**ADDENDUM
NO. 1**

**Carmel Clay Schools – Elementary SRO Offices 2022 Re-Quote
5201 East Main Street
Carmel, IN 46033**

Carmel Clay Schools SRO Office Projects

Project No. 221043.00 – Cherry Tree
Project No. 221044.00 – Forest Dale
Project No. 221045.00 – Smoky Row

CT-A1.01

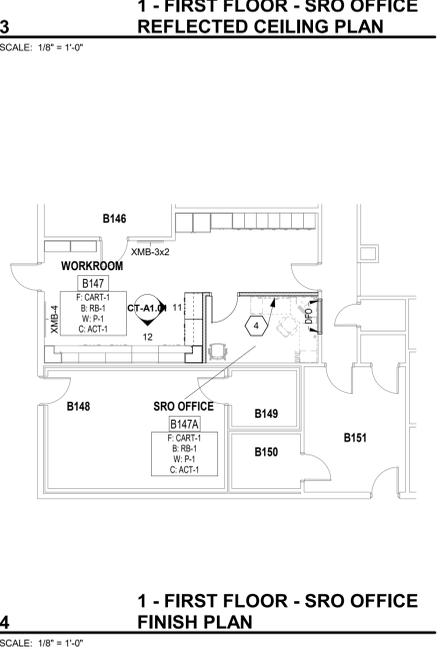
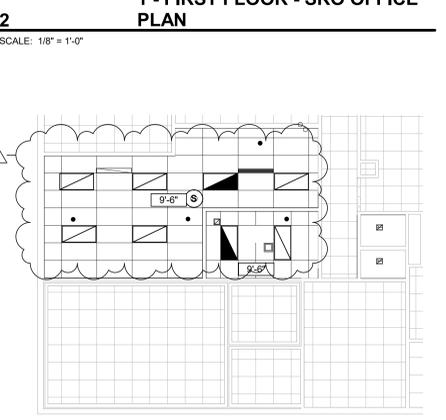
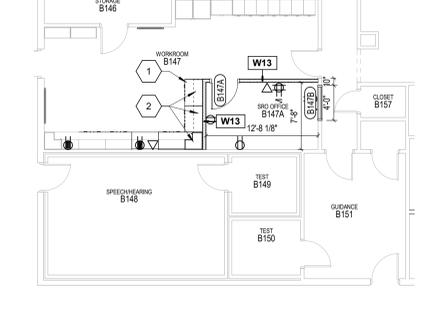
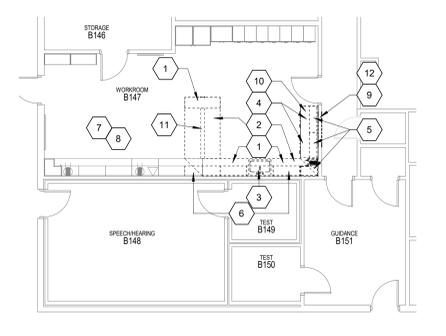
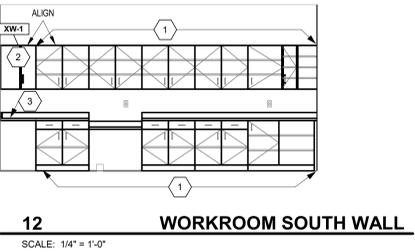
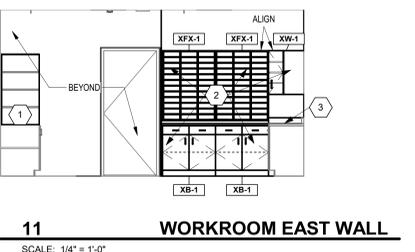
- B. Please confirm if the two continuous rows of lights at Cherry Tree Elementary is needed?
 - a. Answer: See updated Sheet CT-A1.01.
- C. Please confirm the wall details are to be constructed to the deck at all three schools?

- a. Answer: See updated Sheets CT-A1.01, FD-A1.01, SR-A1.01.
- D. Cherry Tree Demo Note 7 tells us to remove all grid and tile complete. Is this necessary, or can we just remove what we need to install the new wall, then tie the existing grid back in? This would be the same in all schools.

- A. Drawing Sheets: CT-A1.01, FD-A1.01, SR-A1.01 have been revised, dated 01/20/22 and are included with and hereby made a part of this Addendum. These Drawings supersede the original documents.
